BURLINGTON DEVELOPMENT REVIEW BOARD Tuesday November 1, 2016, 5:00 PM Contois Auditorium, City Hall, 149 Church Street, Burlington, VT AGENDA

- VI. Sketch Plan**
 - 1. 17-0432SP; 30-32 Howard St/400Pine St (ELM, Ward 5S) Howard Space Partnership**
Construction of multiuse building for studios, offices and replacement of two residential units.
(Project Manager, Mary O'Neil)

To: Development Review Board
From: Mary O'Neil, AICP, Principal Planner
Date: November 1, 2016
RE: 30-32 Howard / 400 Pine Street ZP17-0432SP

1 GARAGE PLAN
3/16" = 1'-0"

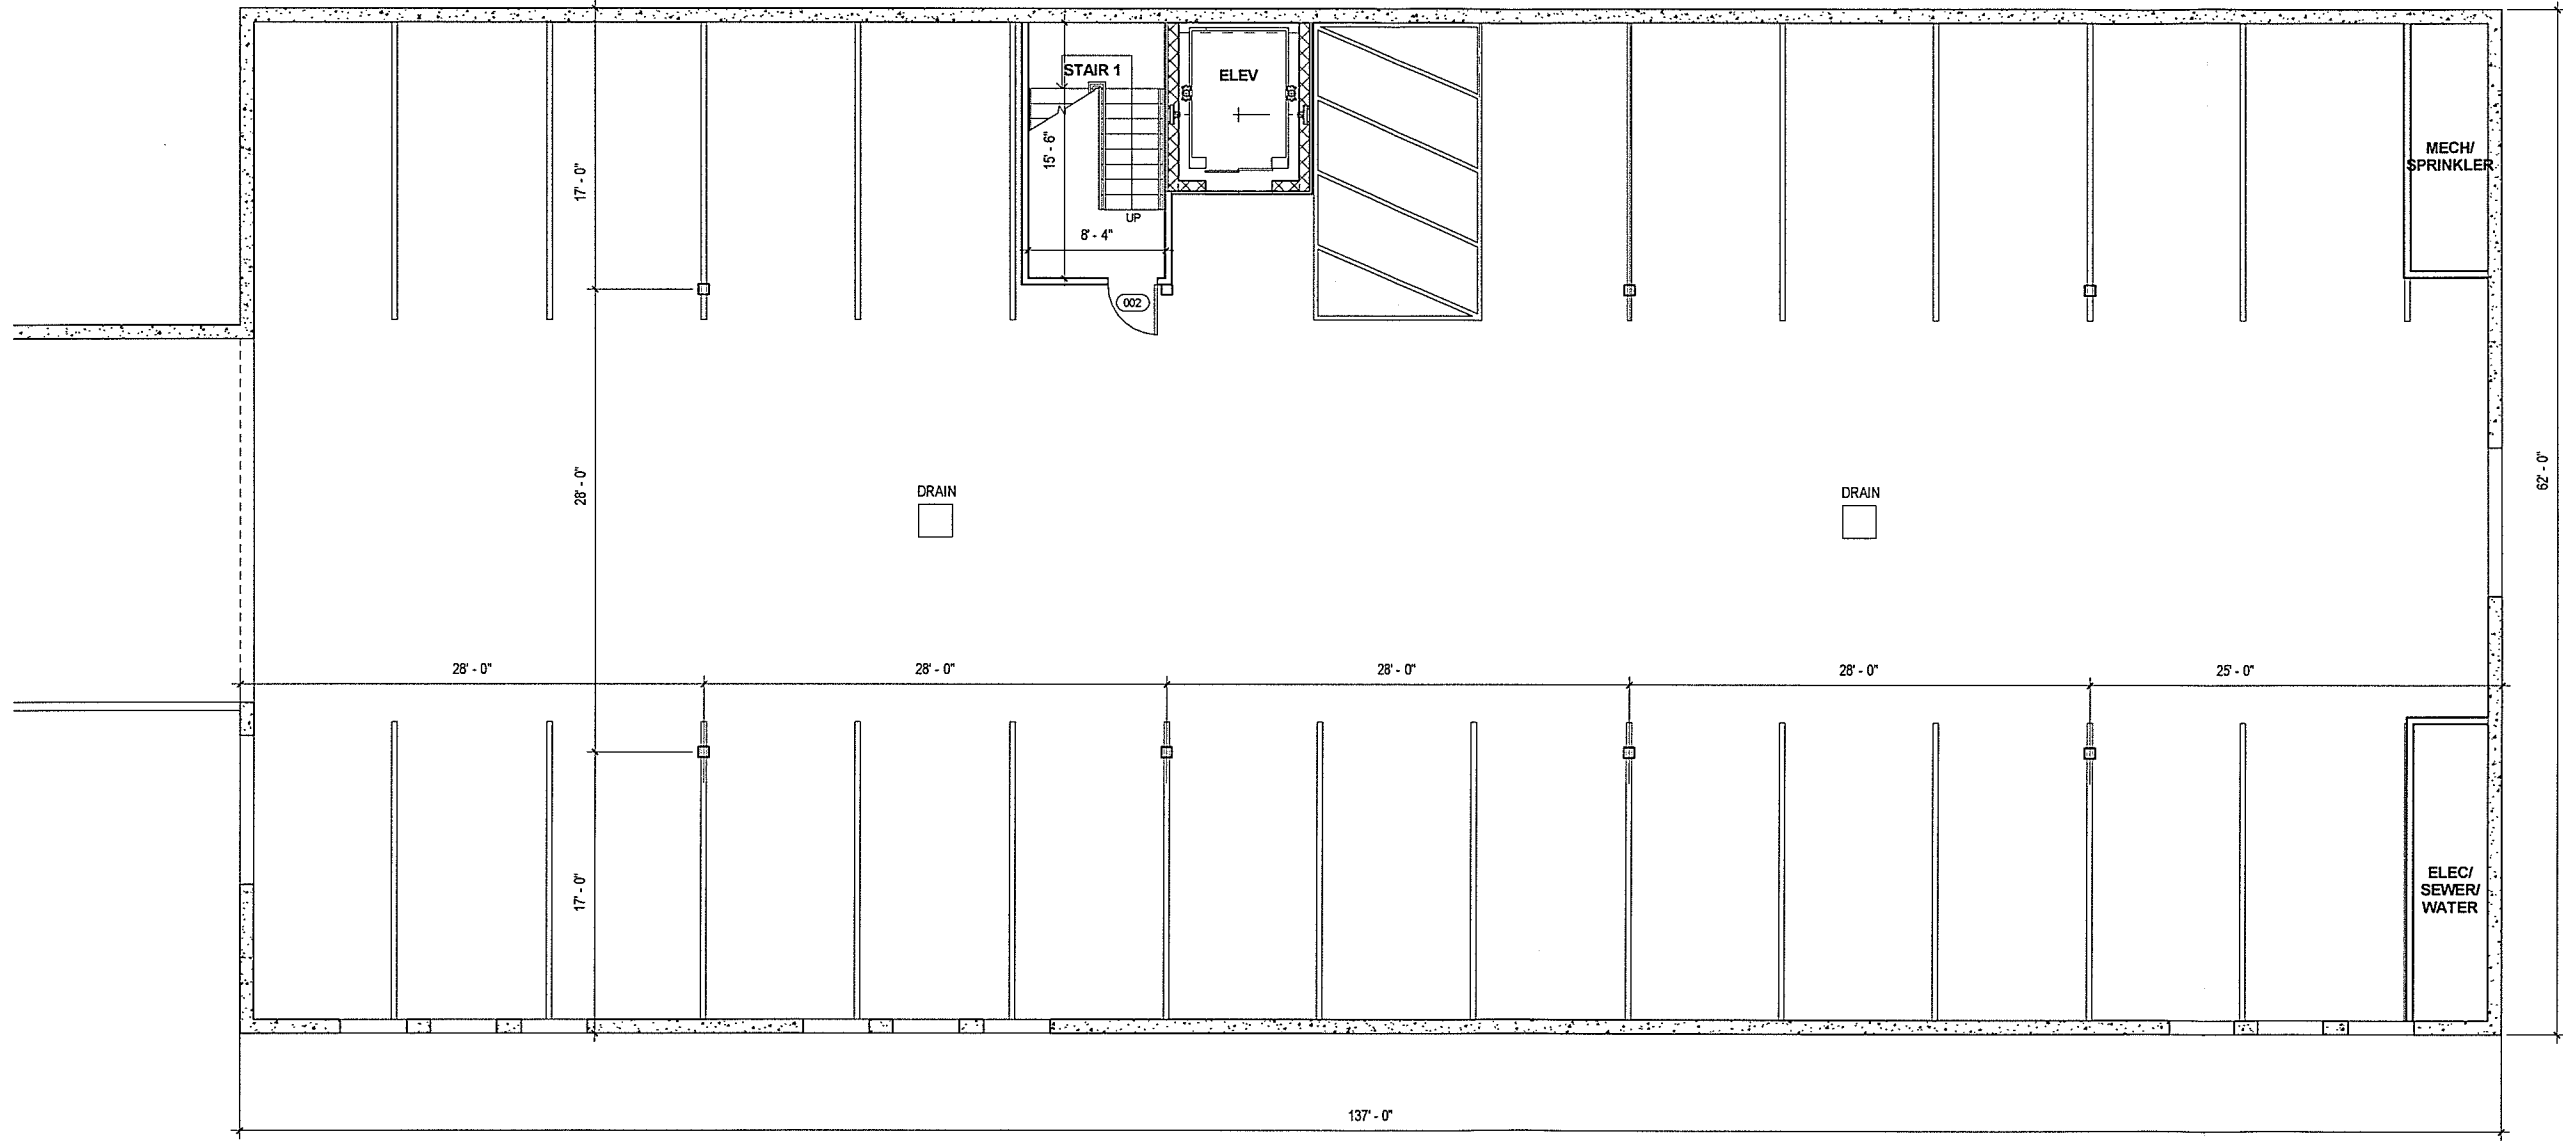
The parking level has identified one handicapped (h/c) parking space with loading area. An exterior ramp is illustrated on the westerly side of the building, terminating at the entrance door. An elevator will serve all three floors and the parking garage. The elevator structure should be illustrated on building elevations as it projects from the roof plane.

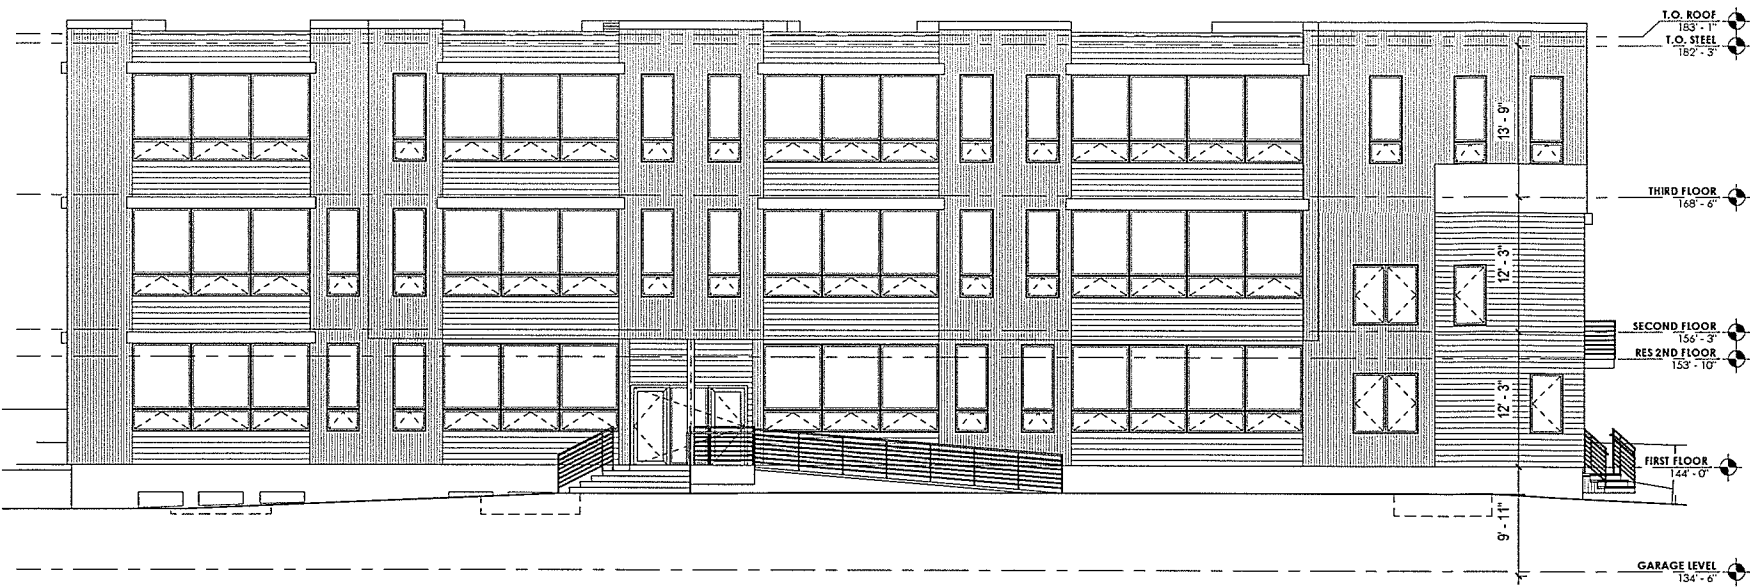
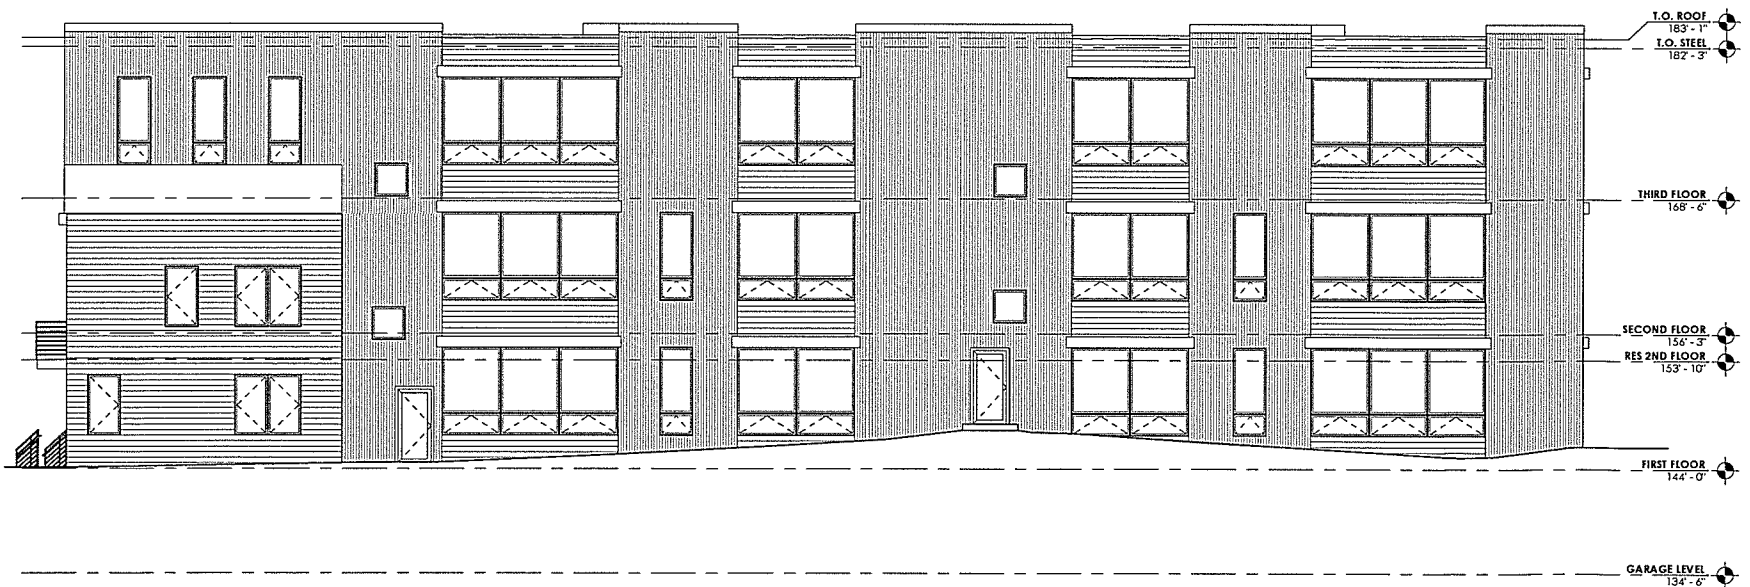
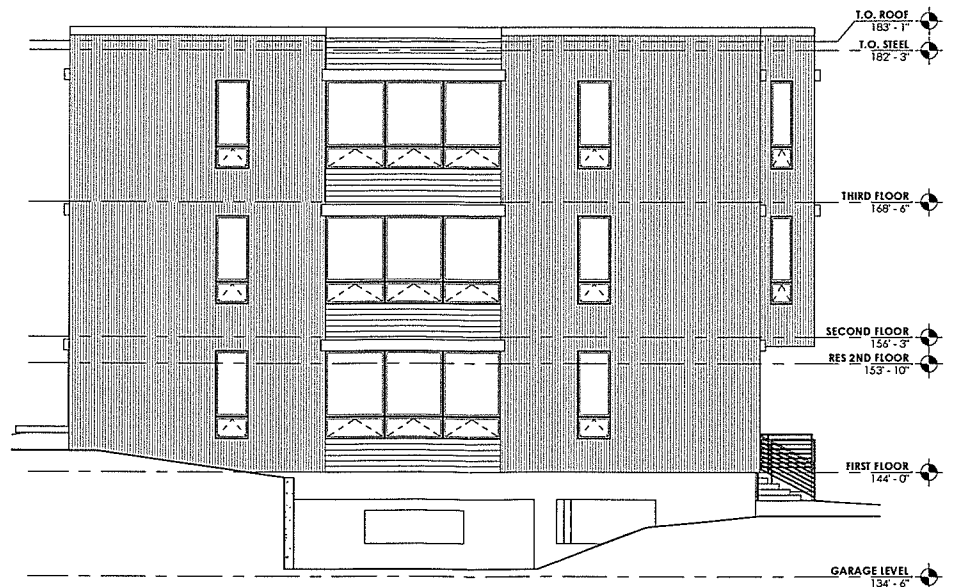
Plan A2.1 illustrates a building height measured from the street front (south elevation) of 39'. If height is measured by the average finished grade of all exterior walls, that measurement may differ.

The applicant shall include any intended rooftop equipment or features in any future application, with a roof plan, to determine area and height of such features.
